**GULF BREEZE CITY COUNCIL
EXECUTIVE SESSION AGENDA**

TO: Craig S. Carmichael, Director of Community Services, City of Gulf Breeze
FROM: Patricia A. Tyjeski, AICP - Senior Planner
SUBJECT: Panera Bread, Preliminary Development Order Review
DATE: August 23, 2013, Revised October 3, 2013

BAKERY CAFE #1725 SITE DEVELOPMENT PLANS

Prepared by: [Signature]
 Checked by: [Signature]
 Date: 09-11-2013
 Job Number: 130067
 File Name: SEE LEFT
 Sheet: **C-201**

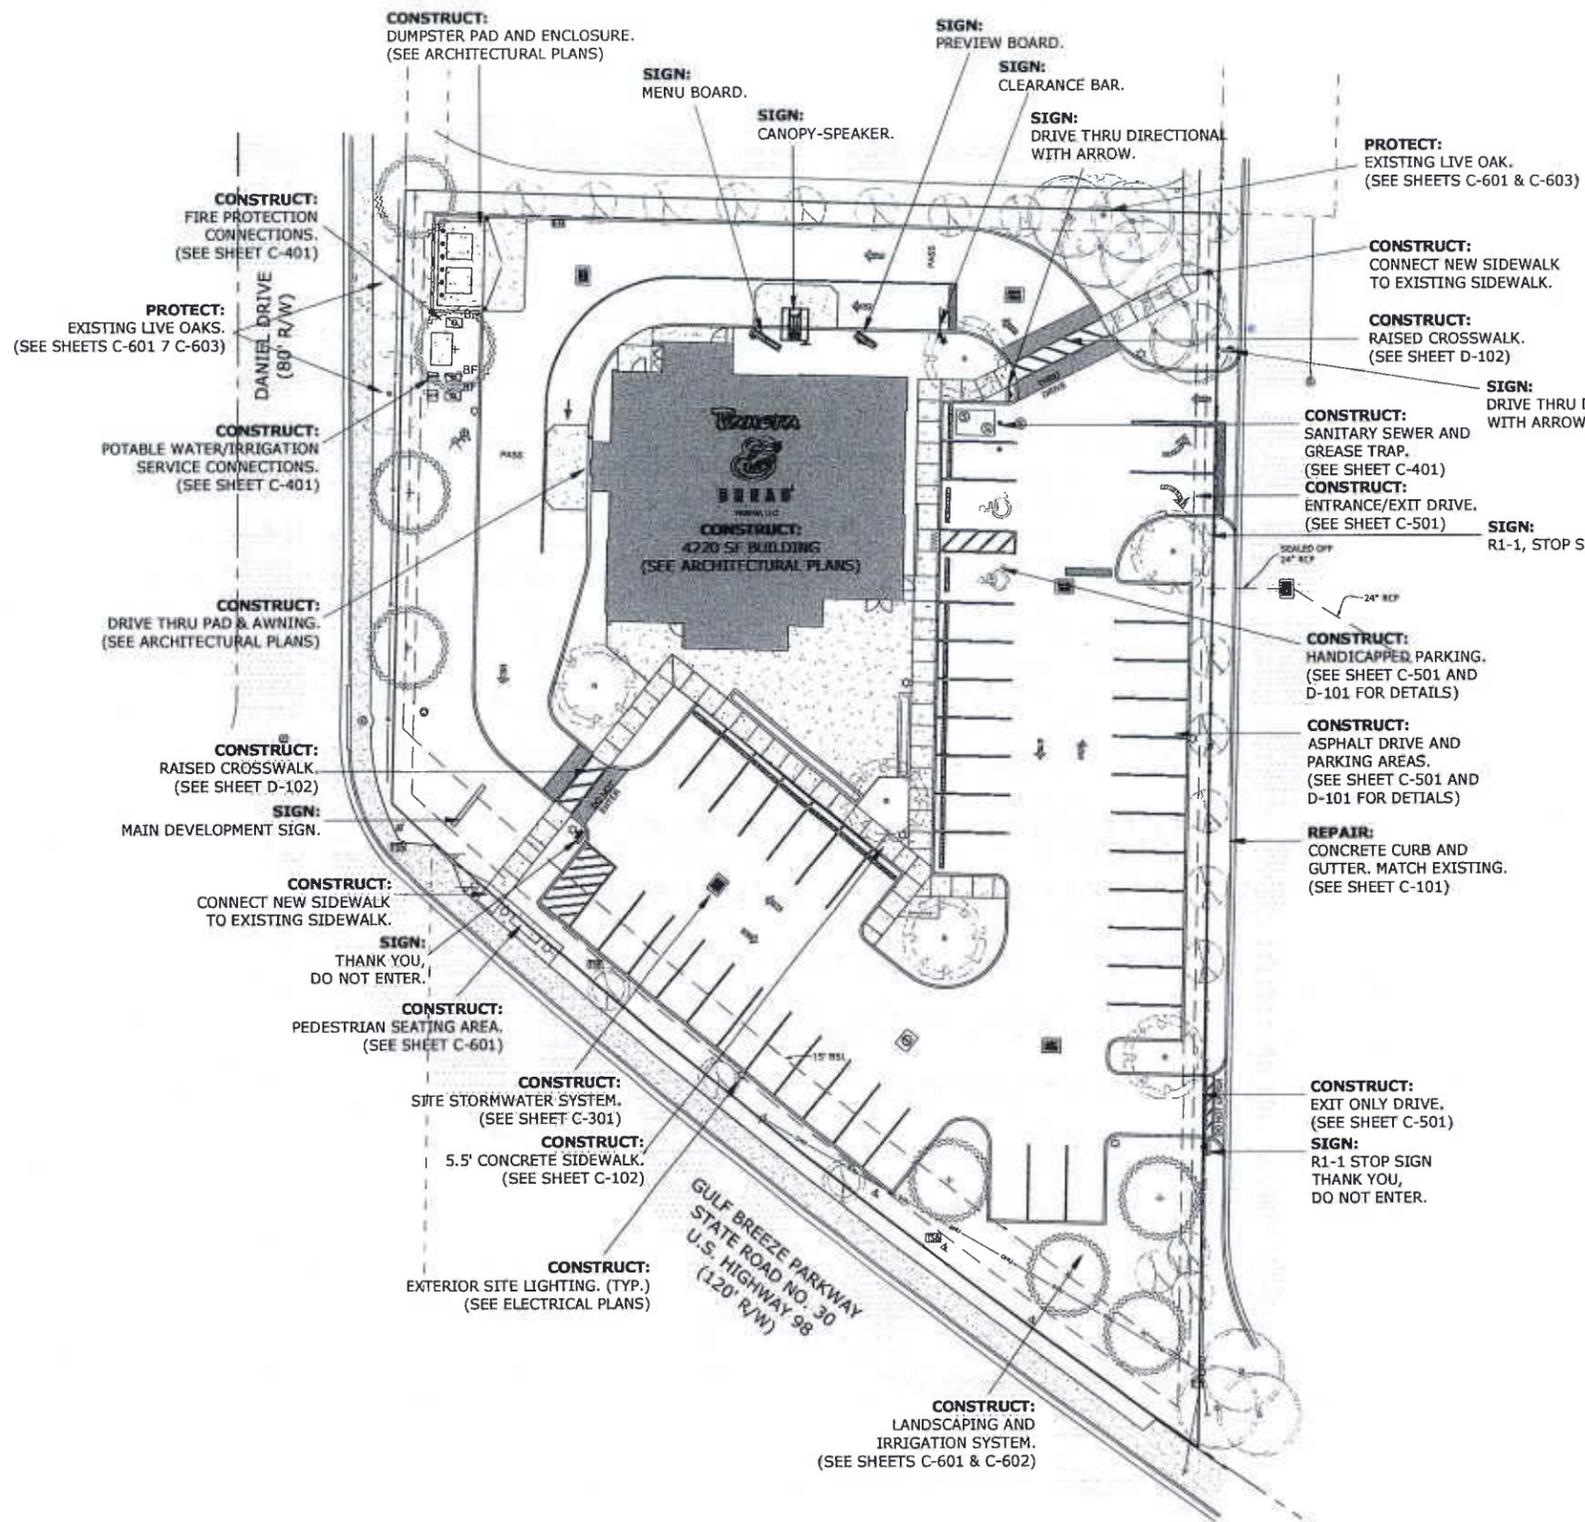
3. On Sheet C-201, show and label the location of the main development sign.

Response: Main development sign is shown and labeled.

Revisions:	
Steve Dana	
NOT FOR CONSTRUCTION	
Florida Landscape Architect #067043	
Designed By: SD	
Drawn By: ES	
Checked By: SD	
Date: 09-11-2013	
Job Number: 130067	
File Name:	
Sheet: C-601

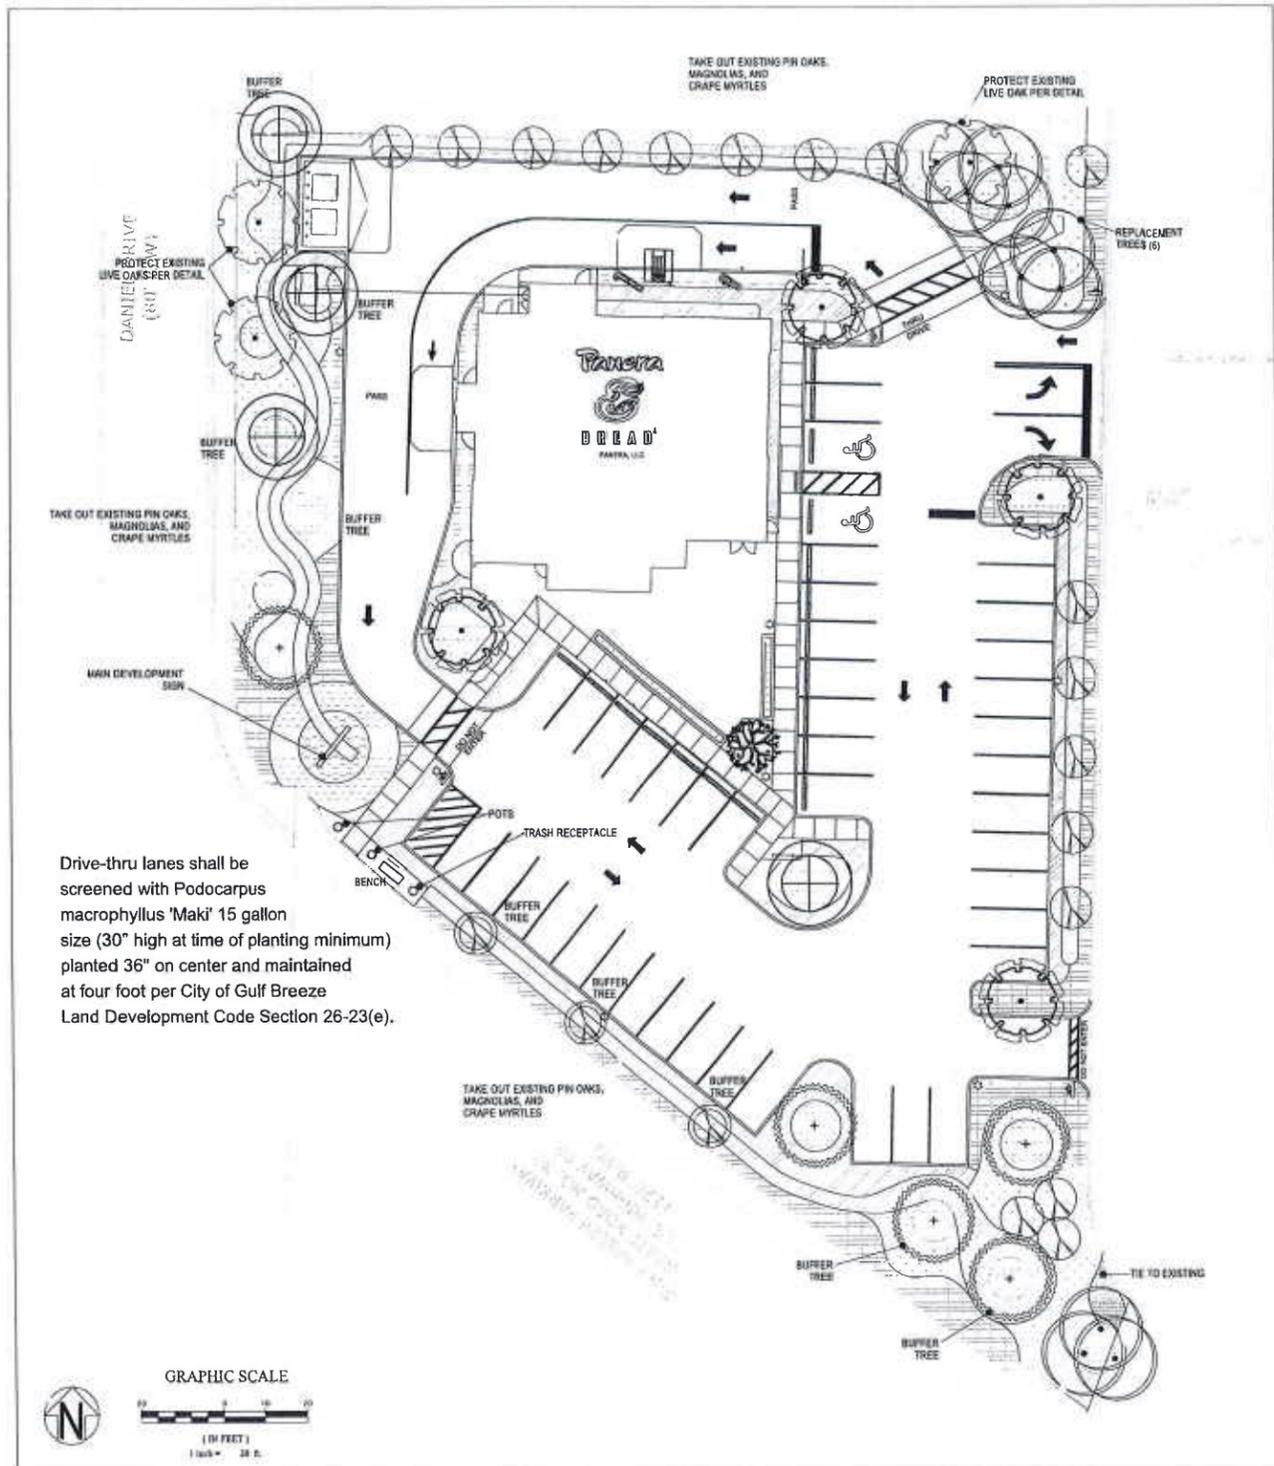
4. On Sheet C-601, label the location of the main development sign.

21. **Section 26-23(e)** requires that drive-through lanes be screened from all rights-of-way with shrubs that are at least 30 inches in height at the time of installation. These shrubs are to be planted 36 inches or less on center and attain a height of four feet within one year of installation.

The landscape plan needs to be revised to meet these requirements. Rotating the building would place the drive-through facing north, avoiding any conflicts with the view from the street.

Response: Main Development sign is shown and labeled.

Response: The landscaping plan has been modified by adding notes specifically requiring minimum heights of 30-inches at planting, maximum 36-inch spacing and 48-inch height requirements within 12 months. Rotating the building destroys the drive thru stacking and parking totals for the project.

EAST ELEVATION:
1/8" = 1'-0"

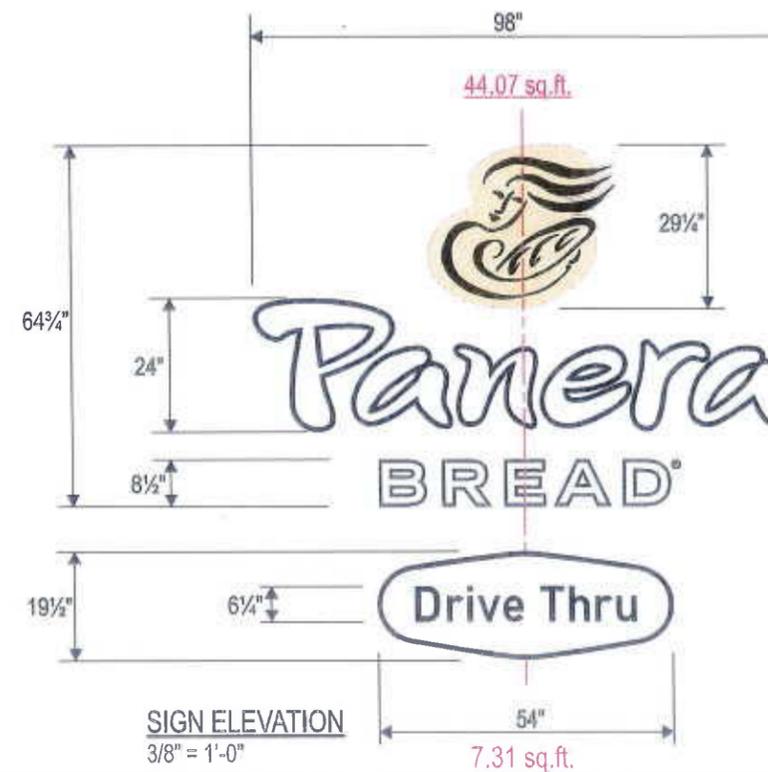
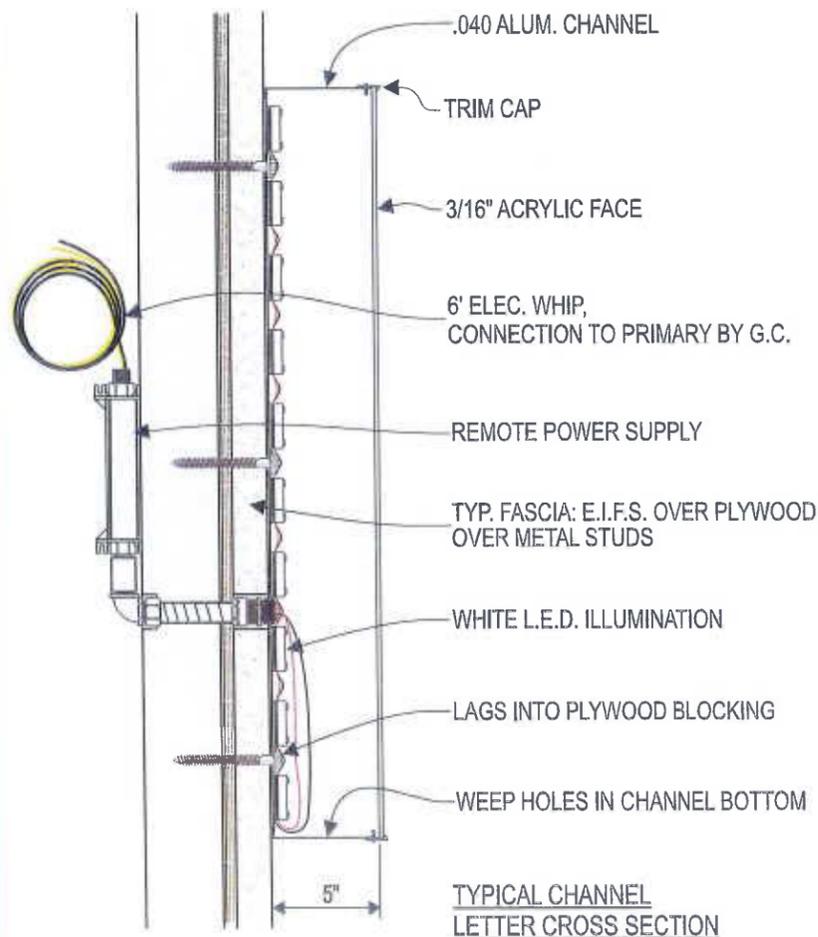
On the east elevation, the right yellow wall is larger than 20'x10' and does not include any of the required elements. On the north elevation the top 10' of the left parapet does not include any of the required elements. The middle section of the elevation only includes one element (change in plane). Please add architectural elements to the secondary facades to meet the requirements of the code.

LEA Comment (09/18/13): See diagram B for the *east* elevation. Still does not meet code.

Response: On the east elevation an additional storefront with an awning above has been added to the right yellow wall. The north elevation has a change in material from the stone to the stucco and the stucco to the cornice.

- 1) We added a pilaster with the same new profile and details as shown on the other elevations. This was added in the center area to create symmetry to that elevation.
- 2) We added transom/attic windows above the awnings for natural day lighting.
- 3) We added an additional bay of windows. These will have to be either spandrel glazing or receive an applied graphic since the interior area behind this glazing is our service area and back of house. We are open to suggestions on what you would prefer.
- 4) We also added additional details to the tower element on the northeast corner.

WEST ELEVATION
1/8" = 1'-0"

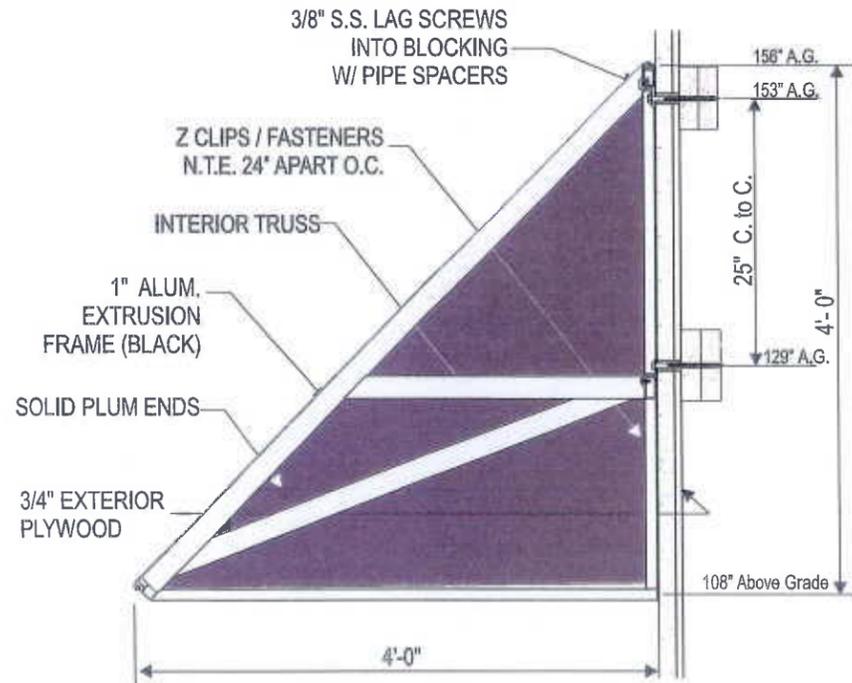
Based on this requirement, the south and west elevations are both primary façades. Please consider adding some of the yellow wall color to the west elevation (facing Daniel Street) so that it appears more like the south elevation (see comment below regarding building style).

LEA Comment (09/18/13): The taller parapet cannot be considered a “tower.” The façade as proposed does not meet the requirement.

LEA Comment (09/30/13): The façade elements on the west and the south elevations are coordinated; however, it appears that the majority of the west elevation will still be brown while the front elevation is yellow, cream, and brown. Coordinated color schemes would make the two sides consistent with each other (see comment #7).

LEA Comment (09/30/13): The revisions satisfy the requirements on the south façade. However, the west façade still has an area larger than 10'x20', as shown in Diagram A, with only two elements (change in plane, awnings). We would suggest a change in color for the drive-through volume, as it would satisfy both this comment and comment #5.

LEA Comment (09/30/13): This comment has not been addressed. Please add the horizontal dimension of the entrance plus the two awnings to determine if they extend for at least 60% of the façade width (they appear to be at $\pm 42\%$). We understand that the function of this façade does not lend itself to the type of treatment required by code, but it is a prominent façade that will be facing a public street. The intent of this code requirement is to create pedestrian activity along buildings facing the street. The west façade is obviously not pedestrian-friendly, but 100% auto-oriented.

LEA Comment (09/18/13): The *south* elevation meets code now. However, the entry requirement along the *west* elevation still needs to be met. It needs to incorporate a clearly defined, highly visible customer entrance featuring no less than three of the elements listed.

LEA Comment (09/30/13): While the applicant has embellished the entrance facing west, we cannot technically agree that it is a "clearly defined, highly visible customer entrance." However, given the additional embellishments on that west façade (arched volume, awnings and cornice/overhang), we would support a *waiver* from this requirement.

Response: The west elevation has been modified to look more like the South elevation. The tower on the right side of the West elevation mimics the tower at the main entrance with stone to 13'0" with a 6" reveal of cast stone with Stucco (Valspar historical color 2002-9a) and 12" cornice above.

Response: We revised the design to add additional characteristics of the “Italianate Style” design and to align with the revisions to the south elevation. Along with that we added the following:

- 1) We added a 3’ deep overhang eave profile and corbels.
- 2) We raised the parapet through the overhang 1’-4”.
- 3) We added an arch-headed profile above the awnings and recessed that 4”/ the goose necks and awnings would be set within the recess.
- 4) We added a 2’-0” high limestone or precast base at the base of all of the pilasters. That will have a chamfered edge at the top.
- 5) We added additional pilaster detailing by adding additional profile moldings near the arched area and at the top on the awning location.
- 6) We added a new pilaster at the northwest corner to balance the elevation. We added a light sconce to that pilaster.
- 7) We added to the building cornice detail and profile to make it more pronounce.
- 8) We added to the detail of the entrance beyond on the west elevation. Additional information is called out on item #11.

1) The entry on this elevation has been modified. We now have an awning above the door to draw more attention to it. We also added the overhang detail (1'-6") in this area to tie-in with the detail of the entry tower and West elevation façade.

"Per ARB Meeting 10/3/13: Given the additional embellishments on that west façade (arched volume, awnings, and cornice/overhang), applicant has received a waiver from Section 26-8(2)(a) which would require each primary building façade to have one or more clearly defined, highly visible customer entrances."
